Re: Docket No. 40-08502, License No. SUA-1341, Request for Additional Information,  
Wellfield Restoration Report, Christensen Ranch Project

**Responses to NRC Request for Additional Information  
Wellfield Restoration Report, Christensen Ranch Project  
COGEMA Mining, Inc.**

Figure 3. Mine Unit 5, Well 5MW66 Excursion Parameters Data, 2004 - 2009

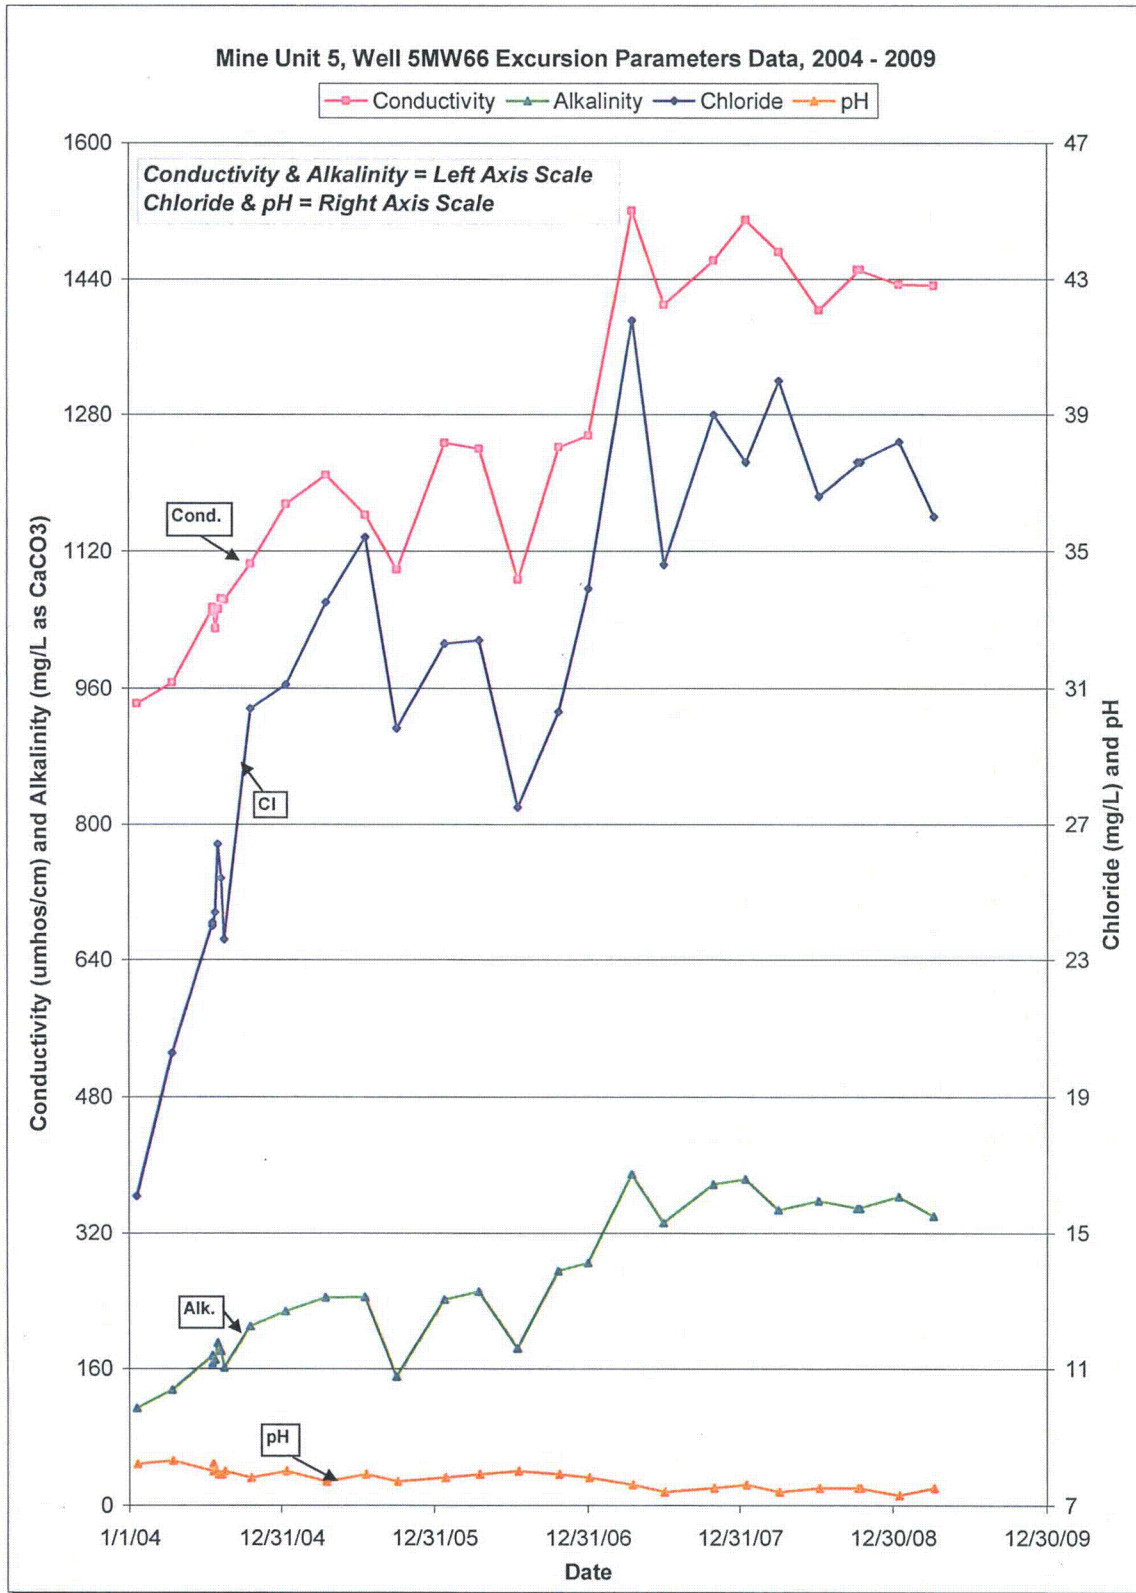
*1. Section 4.6.2. One ore zone perimeter well MU5 (MW66) went on excursion status on July 21, 2004, one month before 4<sup>th</sup> stability monitoring sample. This well is directly downgradient of MOD 55 and has remained on excursion. COGEMA correspondence with WDEQ and the NRC, in the NRC ADAMS records and management system, indicates that WDEQ and NRC agreed that additional restoration or corrective action was not required at the time. Records also indicate that additional monitoring was performed on this well. Submit the additional full analysis (Guidance 8) monitoring data that was performed for this well or show where this information can be found.*

*2. For MW66, demonstrate that sampling taken for the full analysis of monitoring data has remained stable to date.*

As indicated above in comment #1, 5MW66 went on excursion status on July 21, 2004, prior to the collection of the 4<sup>th</sup> round stability monitoring sample on August 9, 2004. Additional monitoring conducted at this well since that time has included excursion parameters (chloride, alkalinity, pH, and conductivity). Table 10 presents the results of excursion monitoring conducted at this well from July 1996 through April 2009. The attached Figure 3 presents the graphical trends for these excursion parameters during the years 2004 to 2009. As the graphs indicate, conductivity, chloride, and alkalinity have generally increased and pH has generally decreased since 2004 when the well went on excursion status. These parameters have remained relatively stable from approximately 2007 to the present.

FIGURE A-10  
 MANGANESE CONCENTRATION DATA  
 STABILITY ROUND 4, MINE UNIT 4

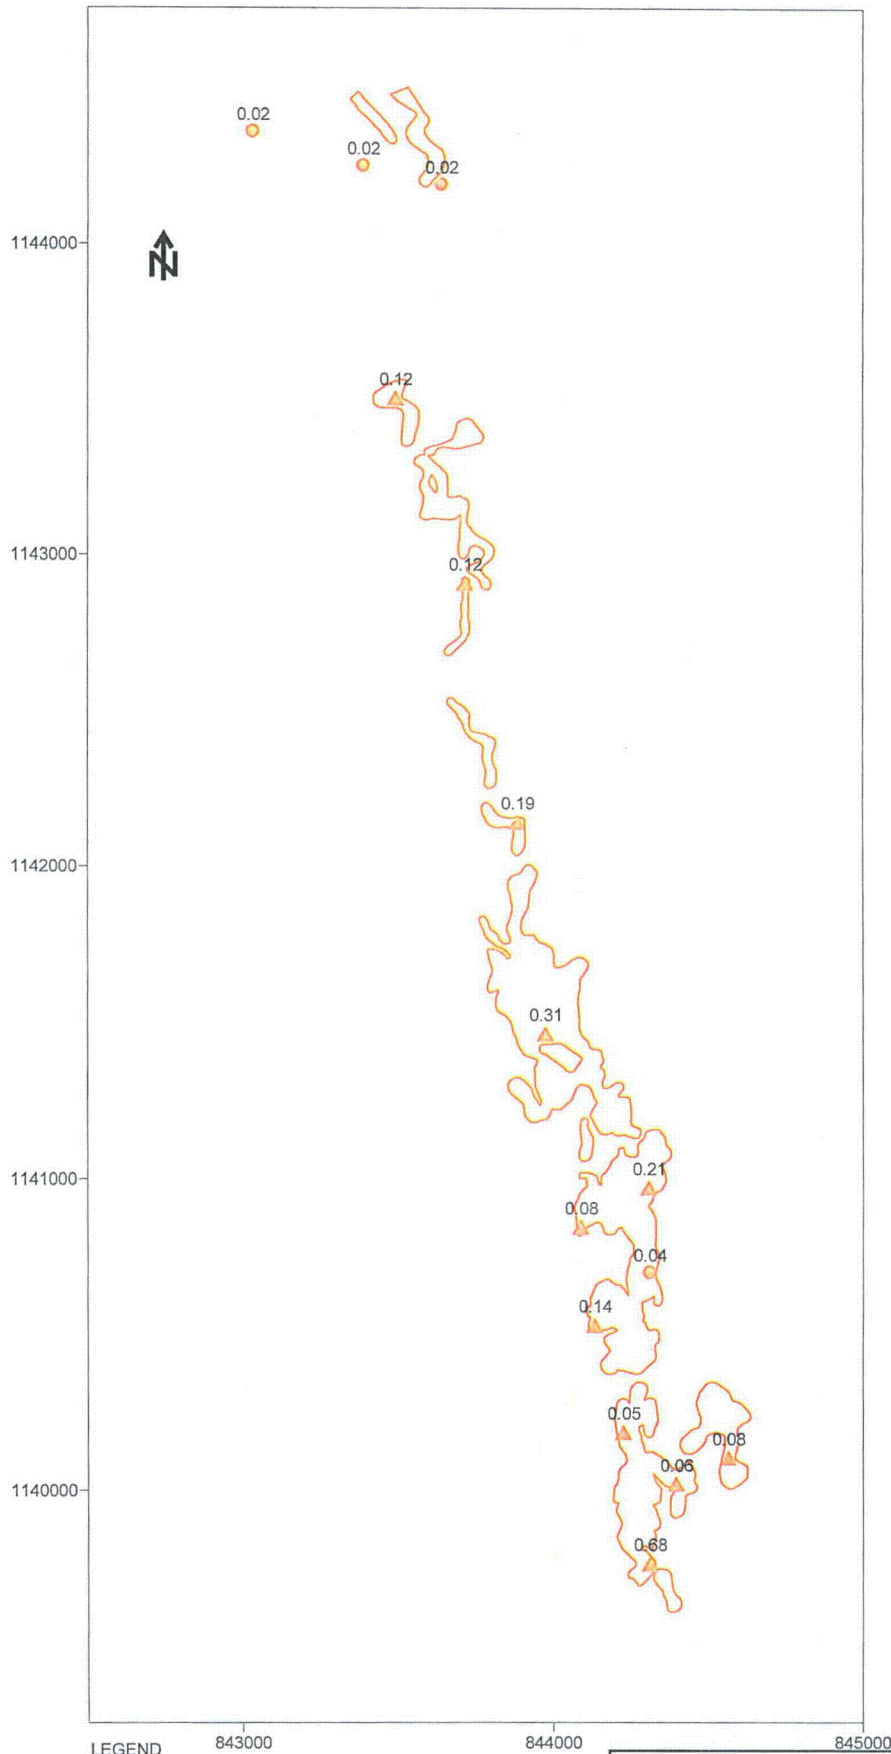
The above figure has been revised to include text indicating the constituent concentration of 16.0 mg/L. Additionally, Figure A-10 presenting manganese concentrations for the stability round 4 monitoring was revised to include data that was missing for well 4T114-1. Revised Figures A-13 and A-10 are included in Attachment 4 of this document.

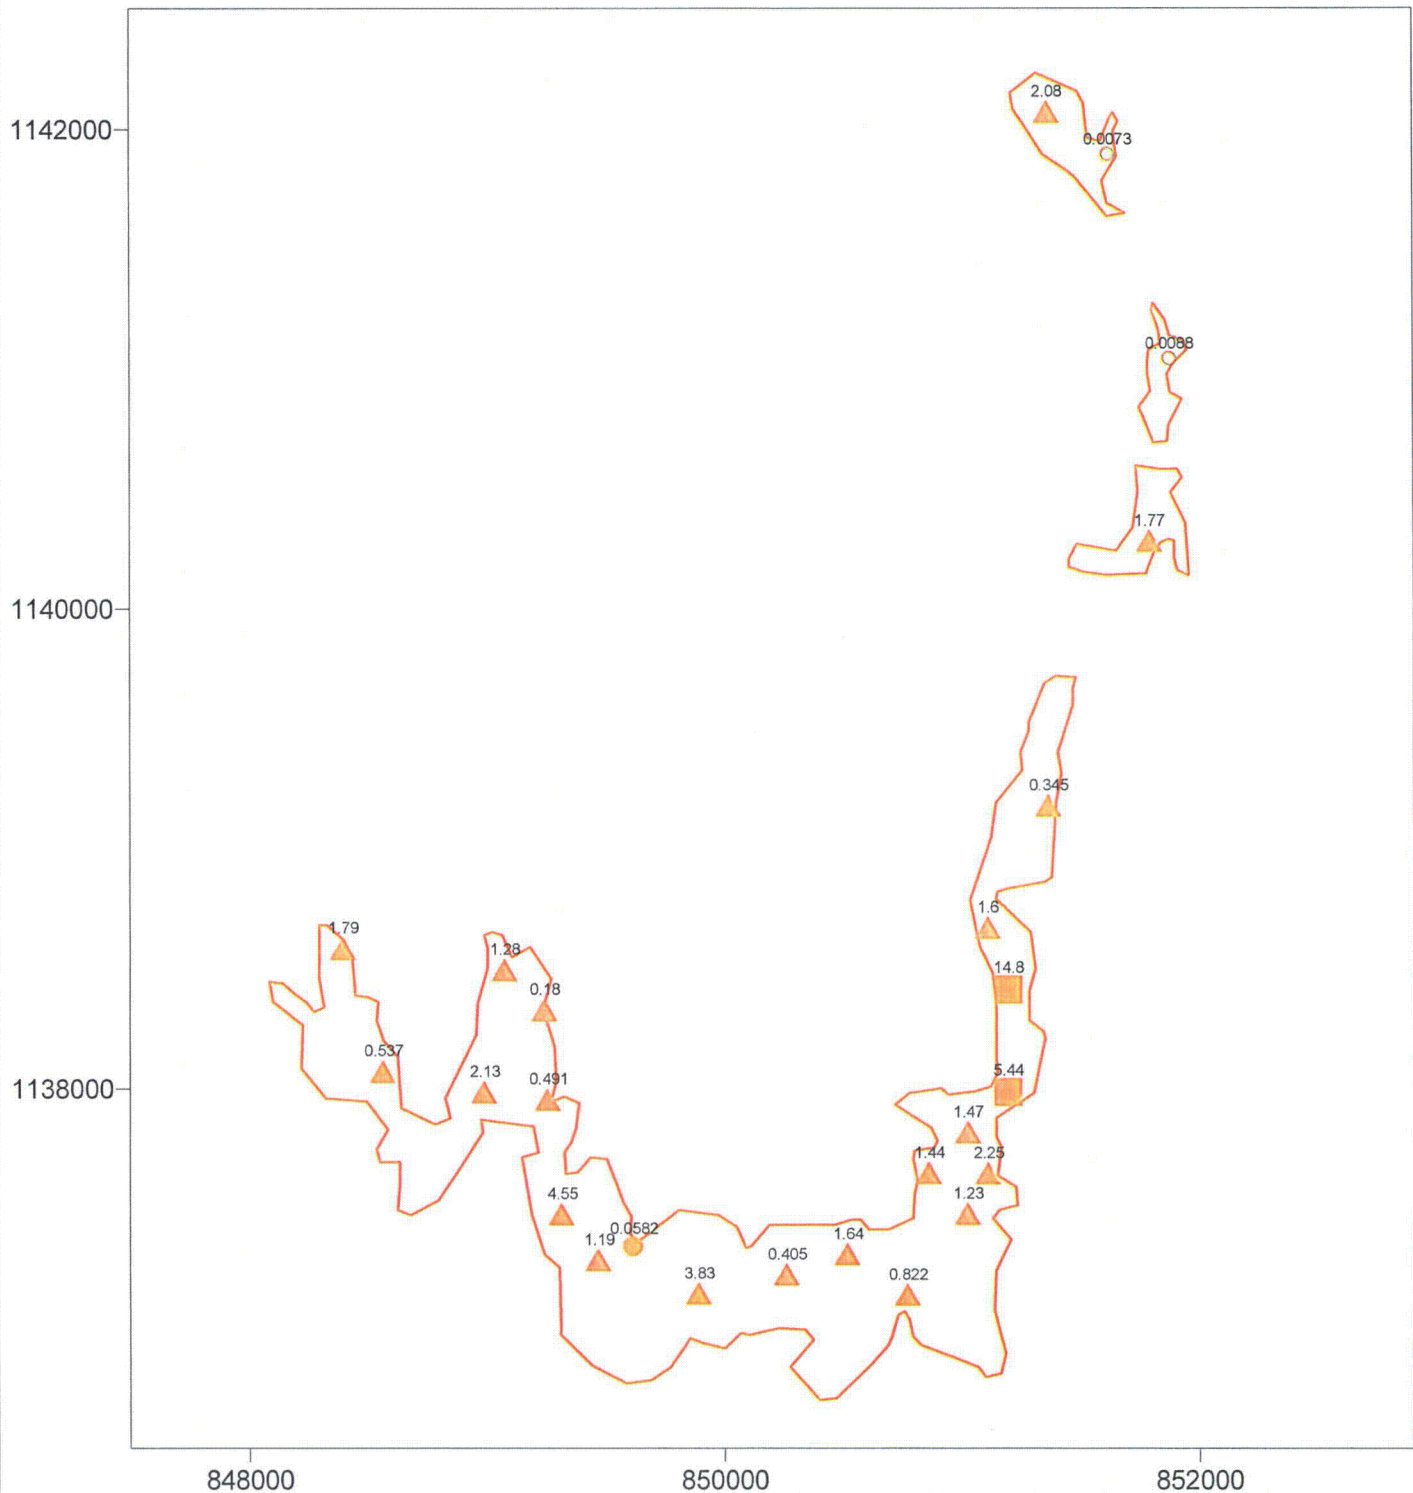
*1. Figure A-13. This figure appears to be missing data point 4T114-1, with a uranium value of 16.0 mg/L. Review this figure and indicate if it is correct as shown, or modify as necessary.*

*4. Figure A-13 shows uranium values of 7.84 mg/L, 6.17 mg/L and if well 4T114-1 is included, 16.0 mg/L, in a small area in the southern most portion of MU – 4. Demonstrate that for this portion of the mine unit that public health and safety is protected in down gradient of the mine unit.*

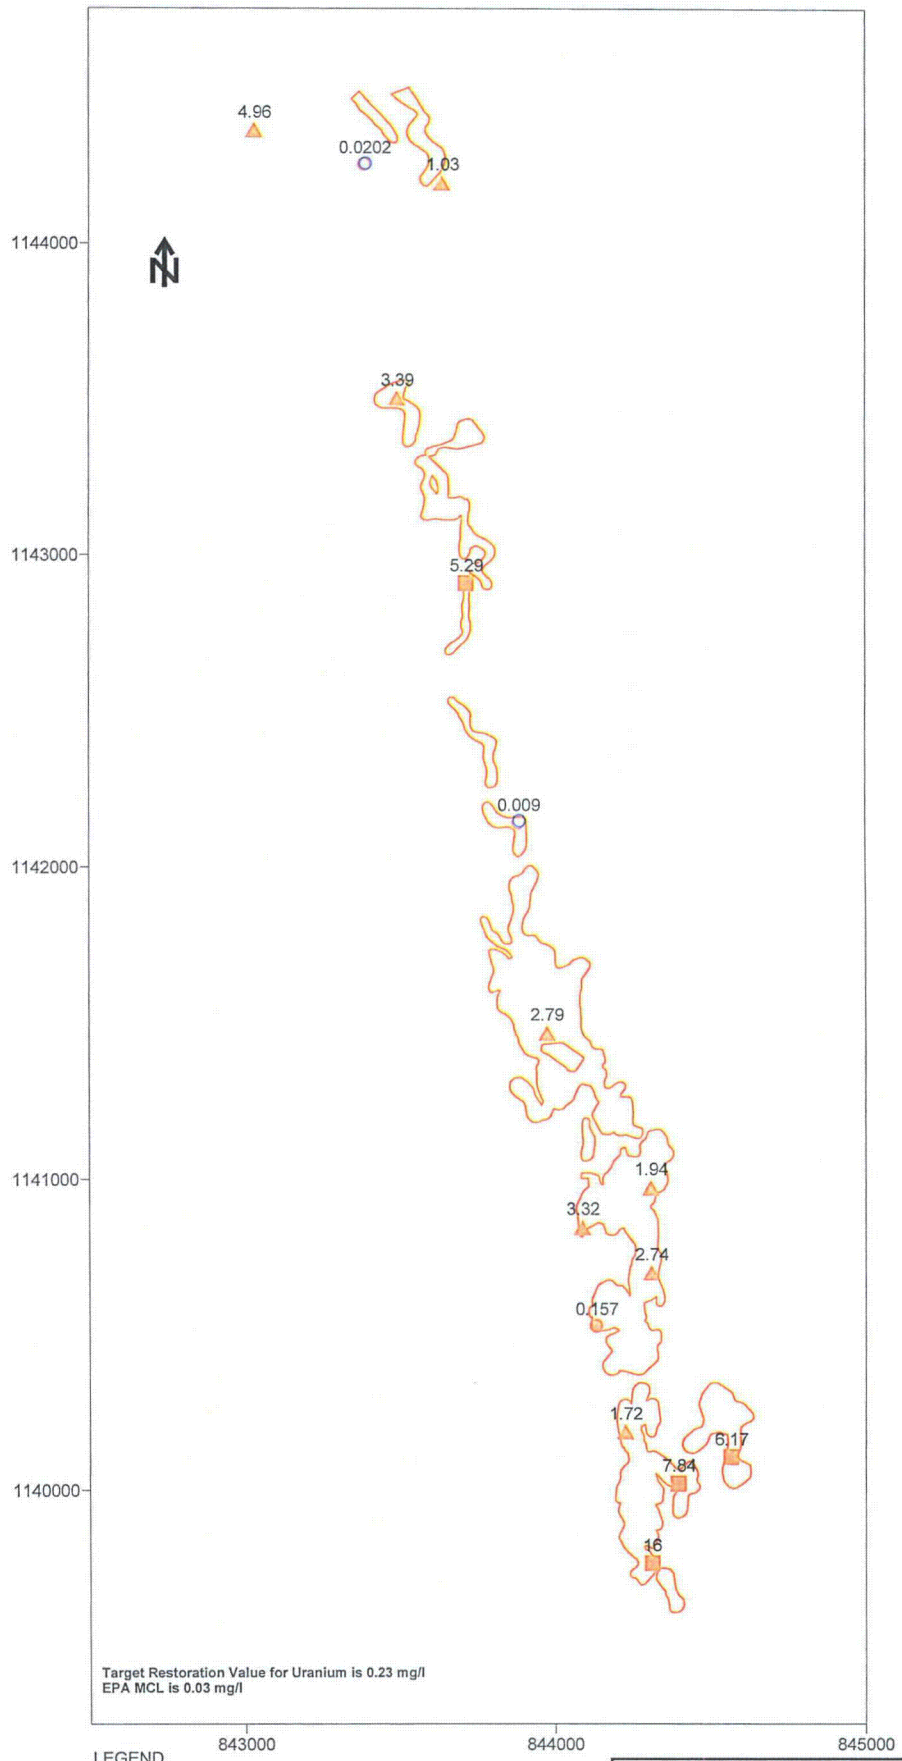
*4. It appears the location of well 5BL76-1 is shown as 2.97 mg/L uranium on Figure A-12. In Table A-1, stability round 4, well 5BL76-1 is listed as 14.8 mg/L uranium. Confirm that this figure is correct or modify as necessary.*

The above figure was revised and corrected to include the concentration values for uranium in Mine Unit 5 from the stability round 4 sampling event. This figure was previously incorrect, as the depicted values represented selenium concentrations. The revised Figure A-12 is included in Attachment 4 of this document.
